Groundwater Application Review Summary Form

Application # G- 18819

SUBJECT: Application G- 18819 Supersedes review of n/a
Date of Review(s)

A. GENERAL INFORMATION: Applicant's Name: Jackson Creek Properties, LLC. County: Columbia

G-18819: Multnomah Channel to Well #3

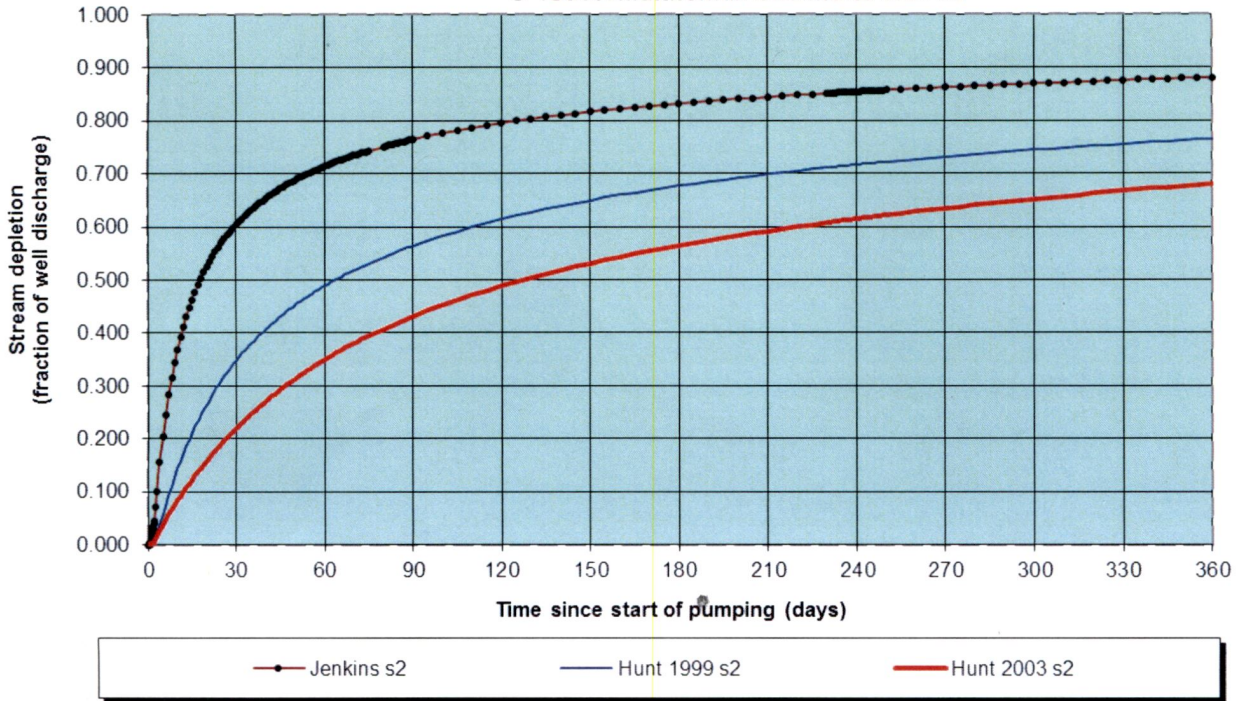
Comments: Pumping impacts to Joy and Jackson creeks will be < 25% of the pumping rate (0.1% to 1.8 % after 30 days of pumping due to the narrow width (~10 ft) of the stream channels, whereas impacts to Multnomah Channel will be 5 to 35 % due to the large width of the channel (~800 ft).

Output for Stream Depletion, Scenerio 2 (s2):					Time pump on (pumping duration) = 365 days							
Days	30	60	90	120	150	180	210	240	270	300	330	360
J SD	60.4%	71.4%	76.5%	79.5%	81.7%	83.2%	84.5%	85.5%	86.3%	87.0%	87.6%	88.1%
H SD 1999	34.9%	48.9%	56.5%	61.4%	65.0%	67.7%	69.8%	71.6%	73.1%	74.4%	75.5%	76.5%
H SD 2003	22.05%	34.99%	43.13%	48.81%	53.07%	56.43%	59.16%	61.46%	63.43%	65.15%	66.67%	68.04%
Qw, cfs	6.900	6.900	6.900	6.900	6.900	6.900	6.900	6.900	6.900	6.900	6.900	6.900
H SD 99, cfs	2.409	3.372	3.895	4.237	4.482	4.670	4.819	4.942	5.045	5.133	5.210	5.277
H SD 03, cfs	1.521	2.414	2.976	3.368	3.662	3.893	4.082	4.241	4.377	4.495	4.600	4.694

G-18819 Jackson Creek Properties, LLC

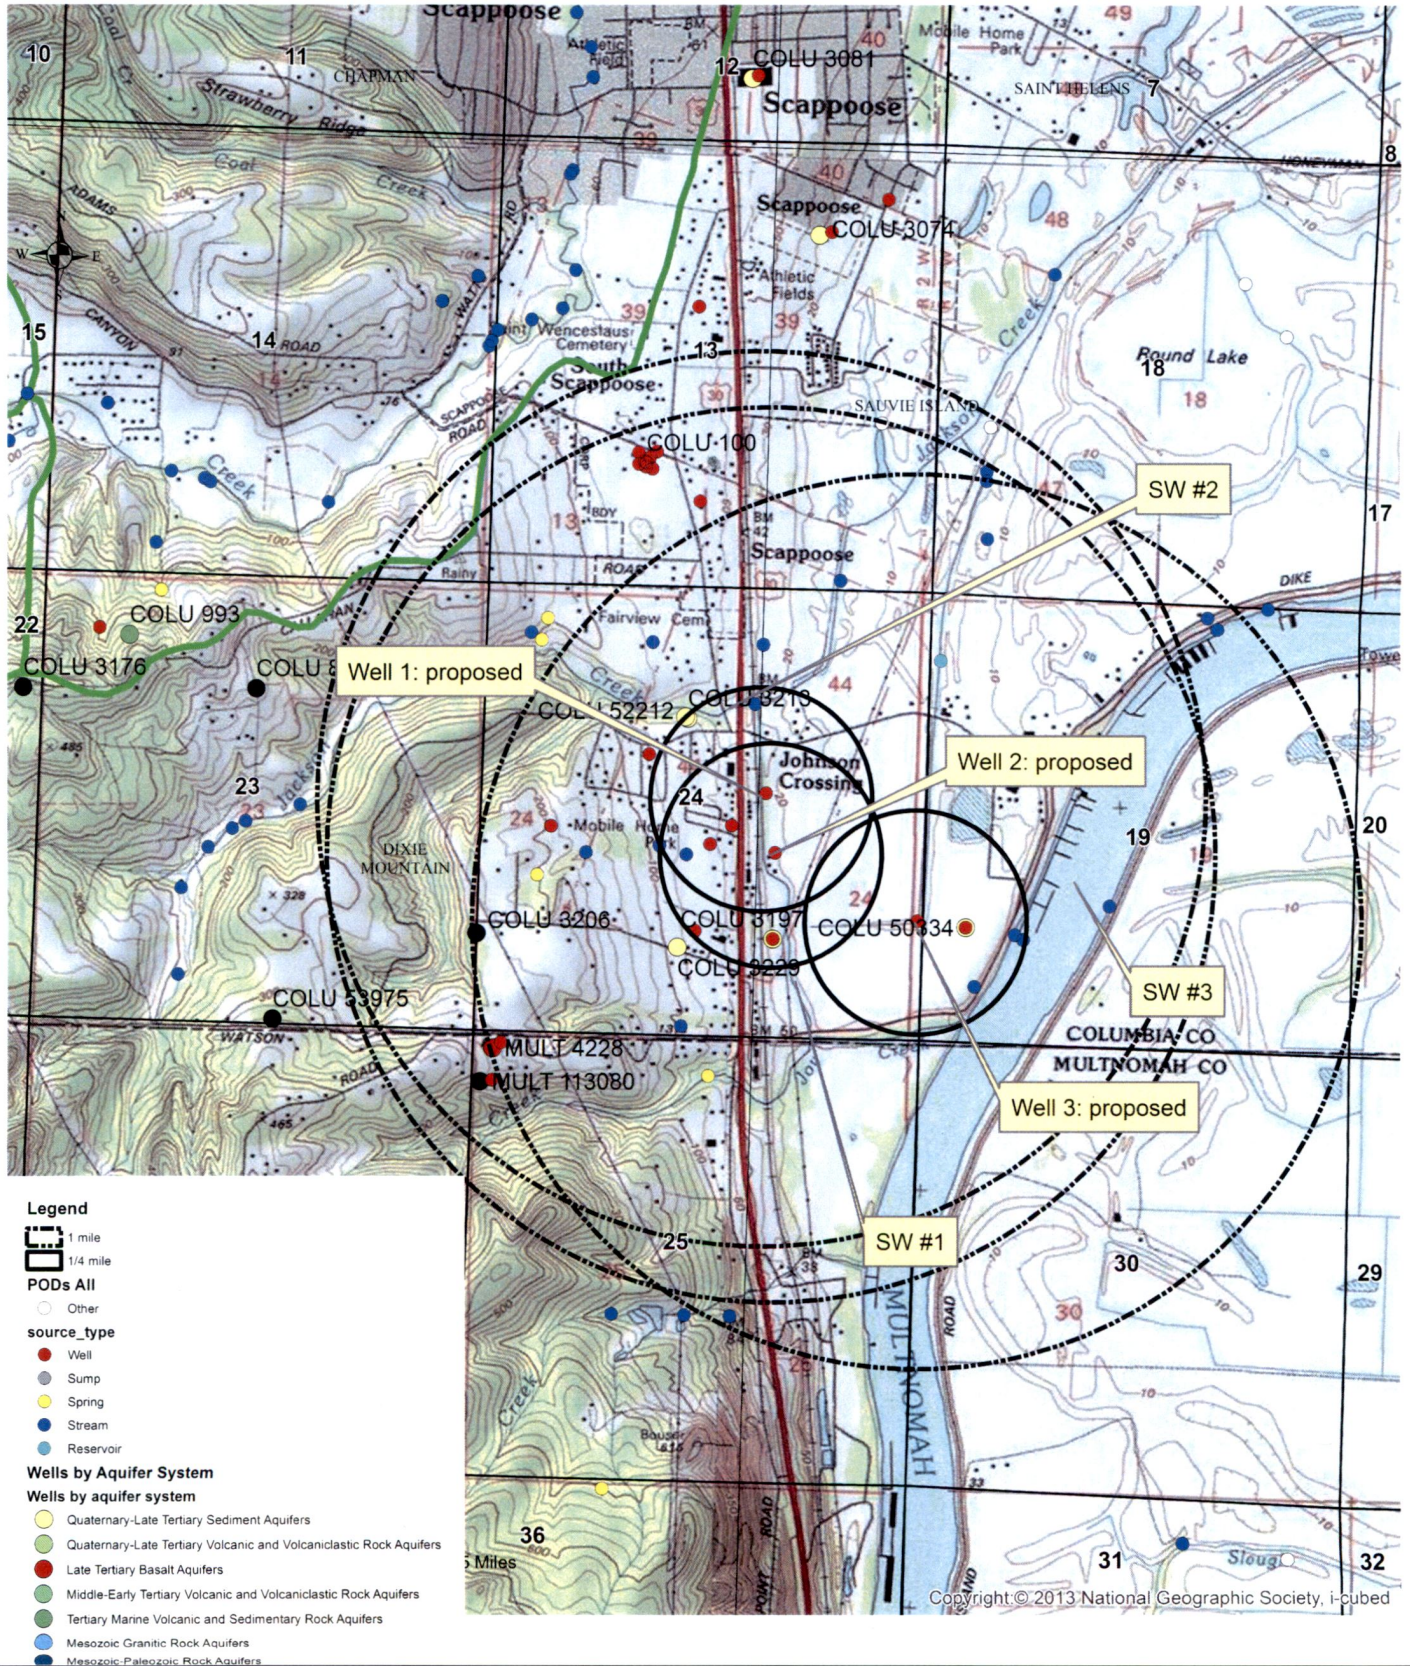
Basis for aquifer hydraulic connection evaluation: Water levels in nearby wells are coincident with the elevations of local surface water sources indicating hydraulic connection between the aquifer system and area streams.
